**Addendum Number 1
California American Water (CAWC)
Construction of ASR Wells 5 and 6
Request for Proposal**

Addendum No. 1 Issued October 9, 2018

**CALIFORNIA AMERICAN WATER
FITCH PARK ASR-5 AND ASR-6 WELLS**

FIGURE 3. PRELIMINARY WELL DESIGN SCHEMATIC
 Fitch Park ASR-5 and ASR-6 Project
 California American Water

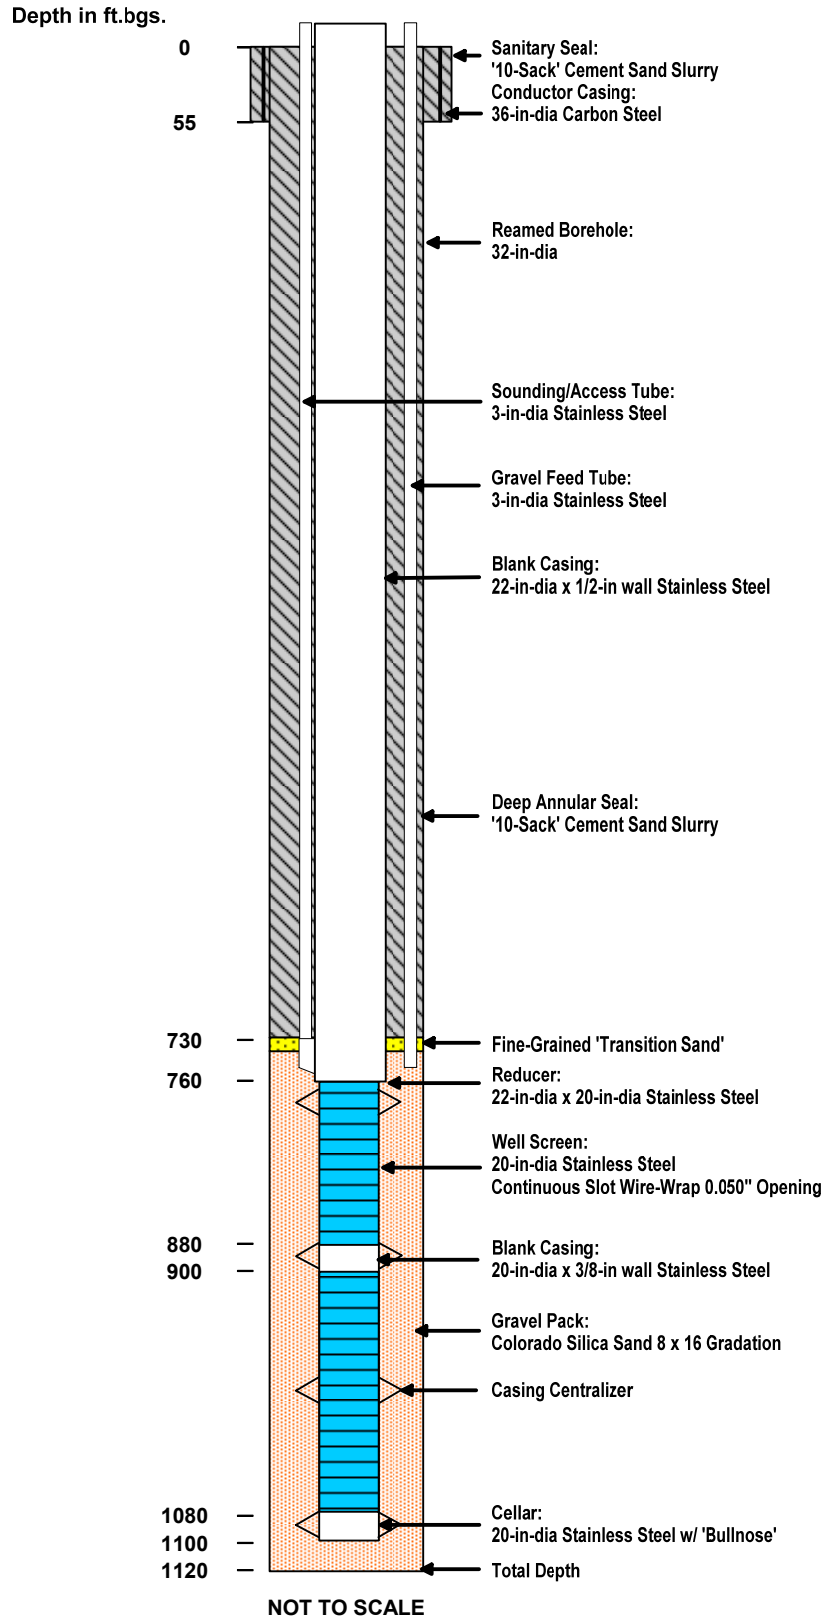
1. SECTIONS 106.1.7, 206, and Figure 3. Contractors shall note the discrepancy between the reamed borehole size mentioned in the cited specification sections, and Figure 3. The correct reamed borehole is 32-inch diameter. Therefore, contractor shall now use the revised Figure 3 (11/1/18), which illustrates a 32-inch diameter reamed borehole. A copy of the revised Figure 3 is attached.
